Subject: **FRONT MONITOR LOCATION
PROBLEM**

Bulletin Type: **FIELD FIX CONDITIONAL**

Bulletin No: **TS30-FC-2107**

Vehicle Model: **TS30**

STEP 1

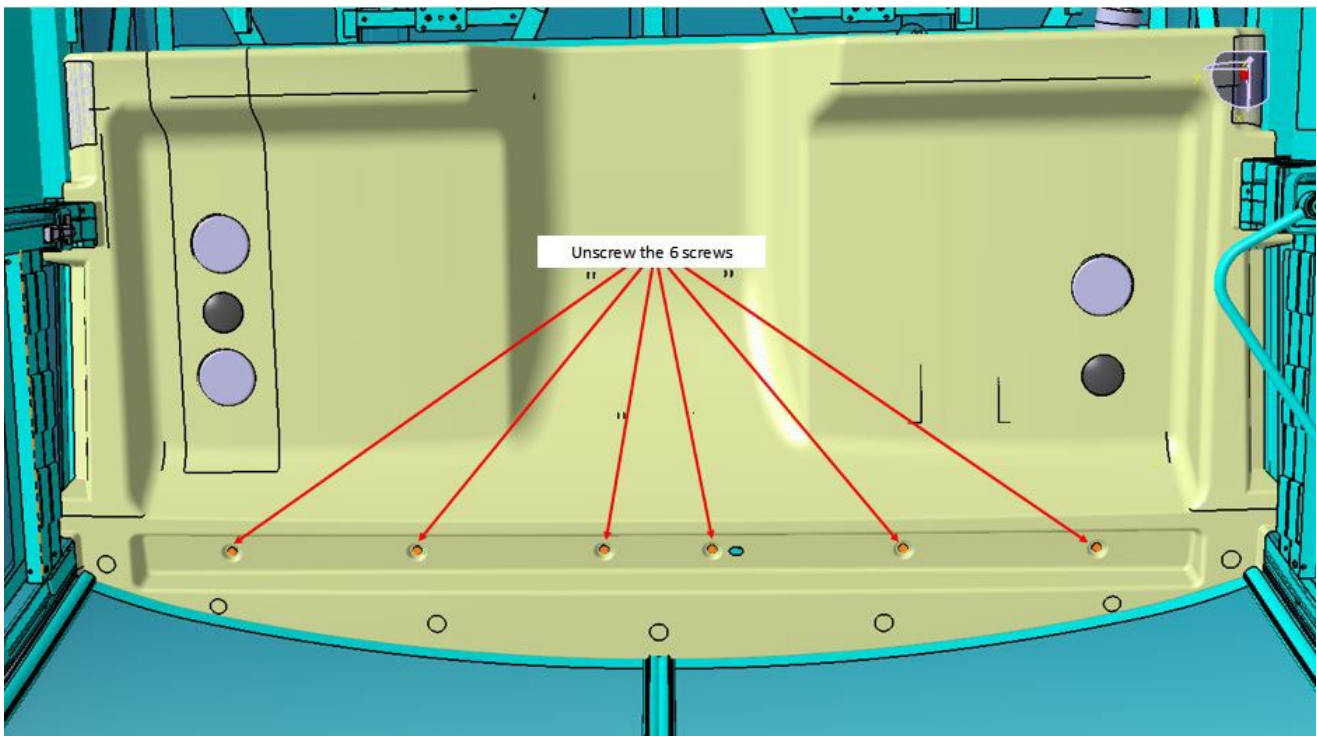
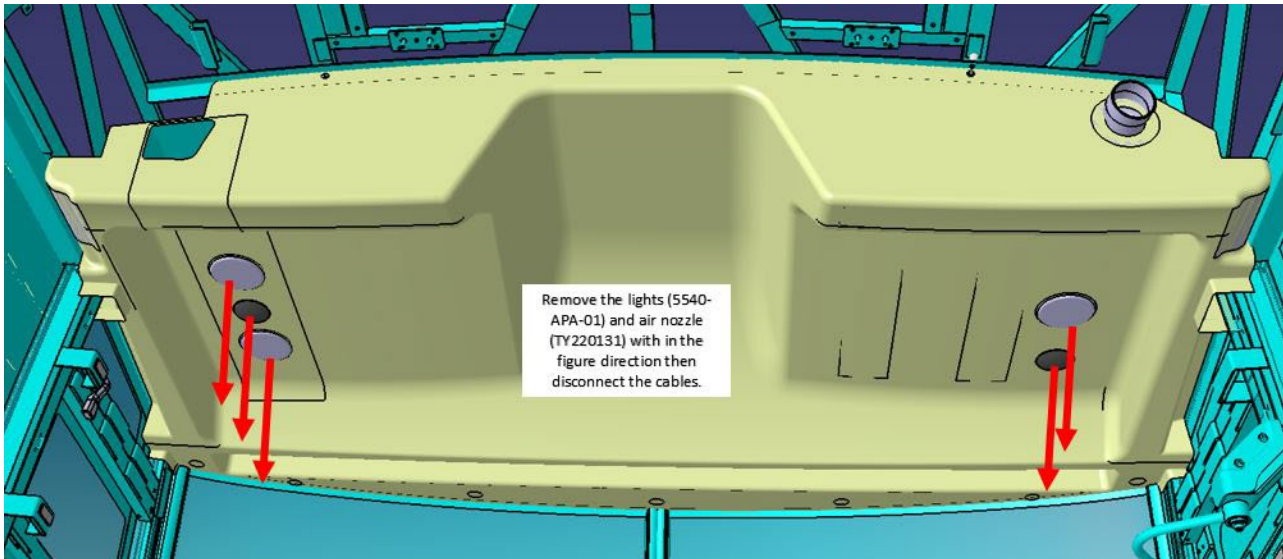
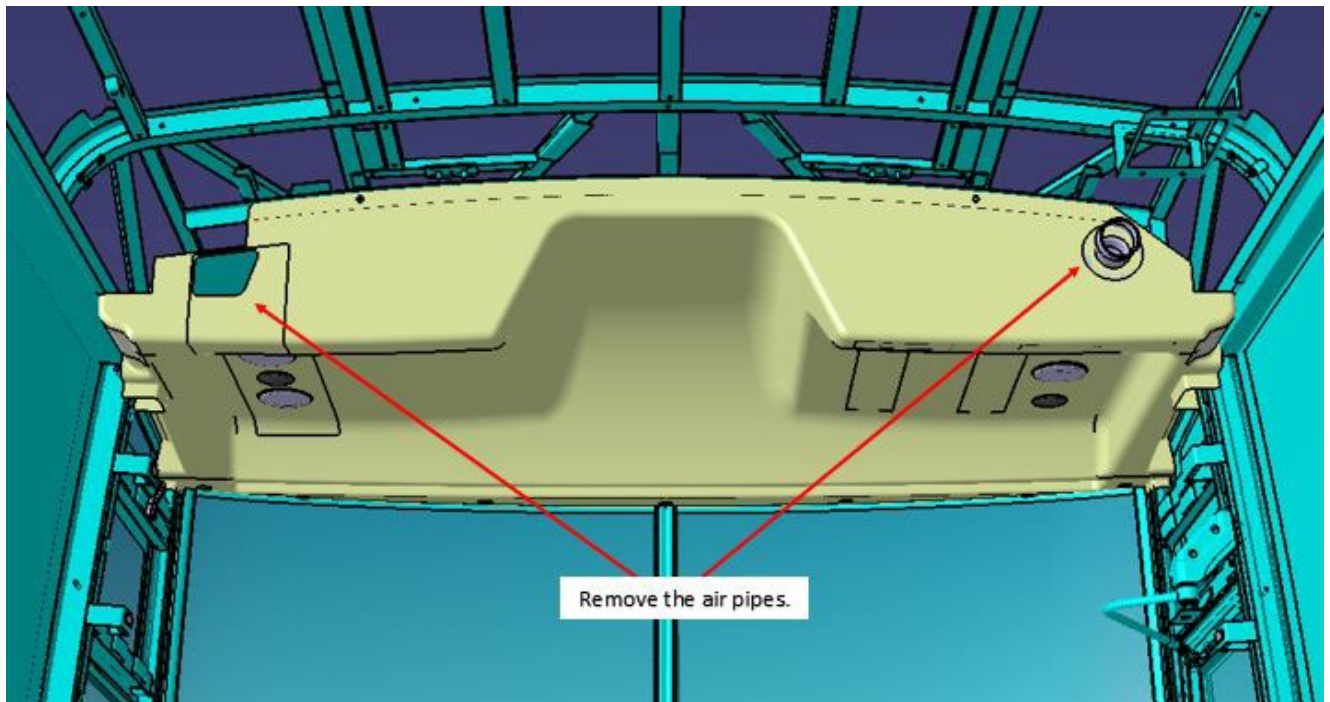
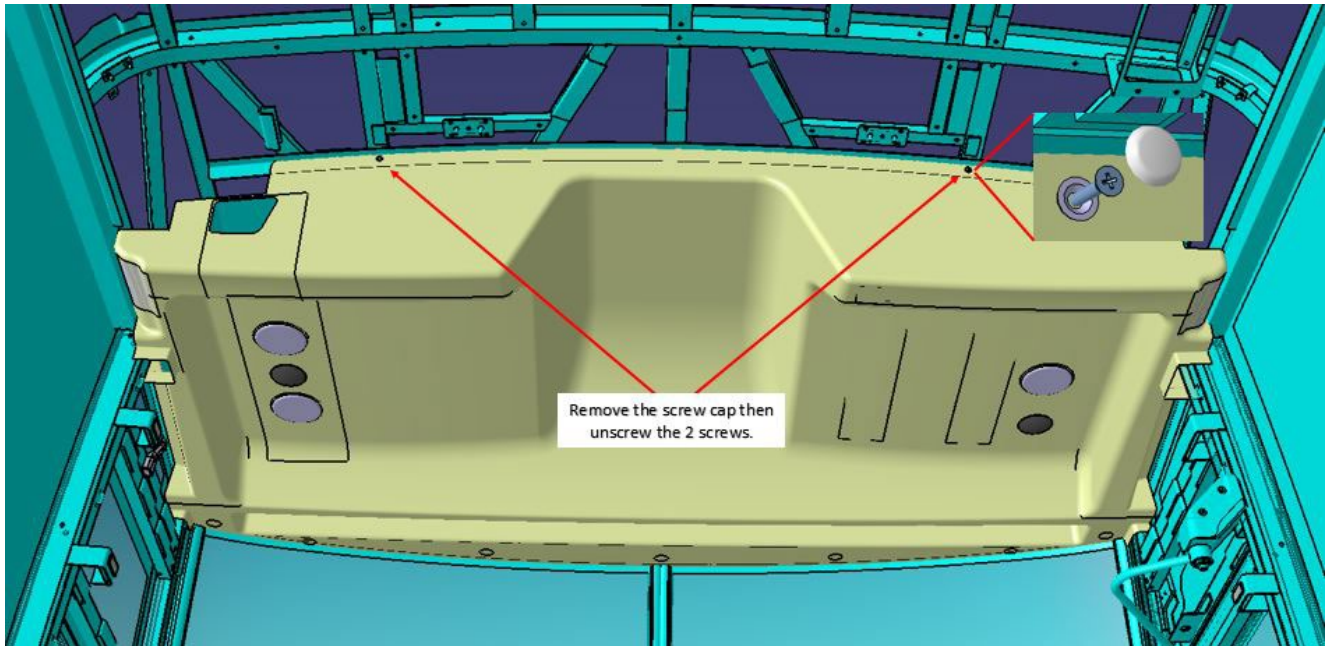
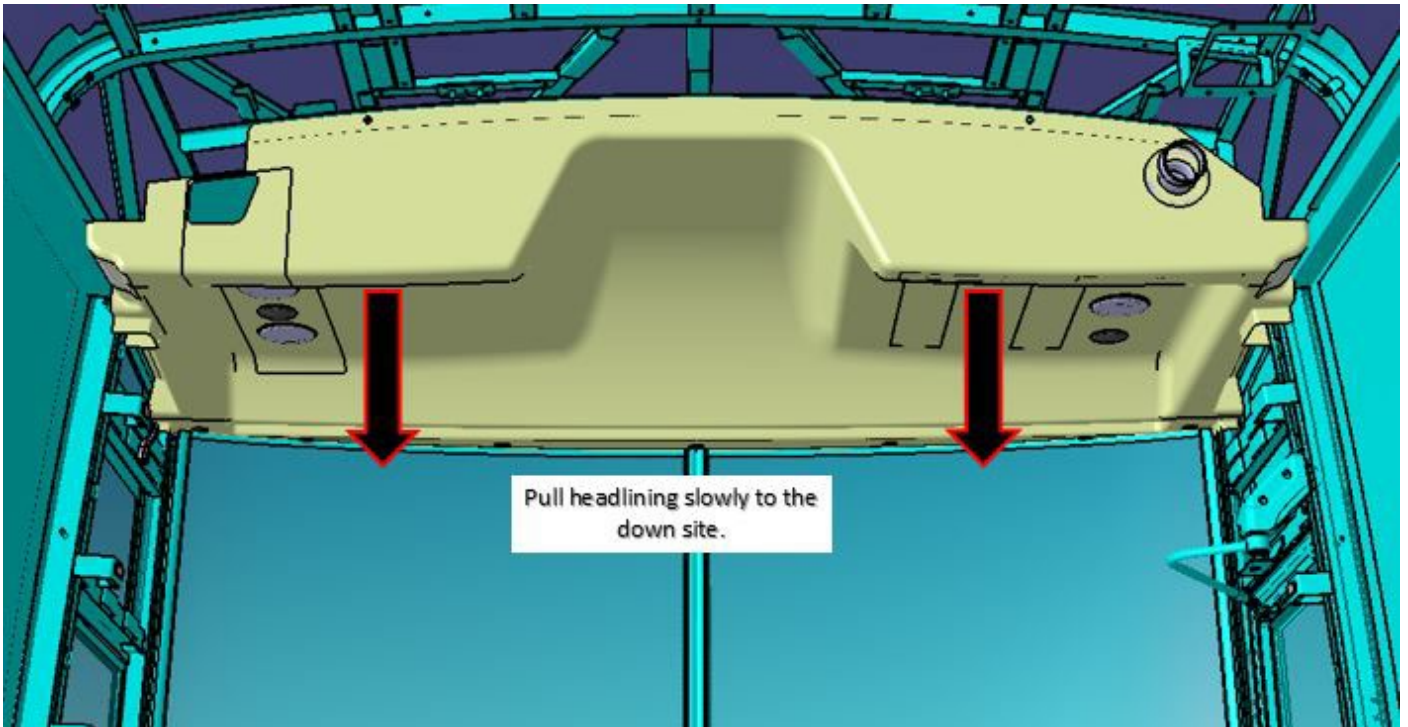
APPLICATION	TIME
Step 1: Remove monitor and side cover.	45
Step 2: Remove the spot lights, air nozzle and headlining.	45
Step 3: Welding sections.	360
Step 4: Assambly the air nozzle headlining and screws.	240
Step 5: Cut the fasteners and placed their places.	90
Step 6: Mount the headlinig and side cover.	400
Step 6: Assambly the partition wall and monitor.	30
Total Labor Time	1210 Min.
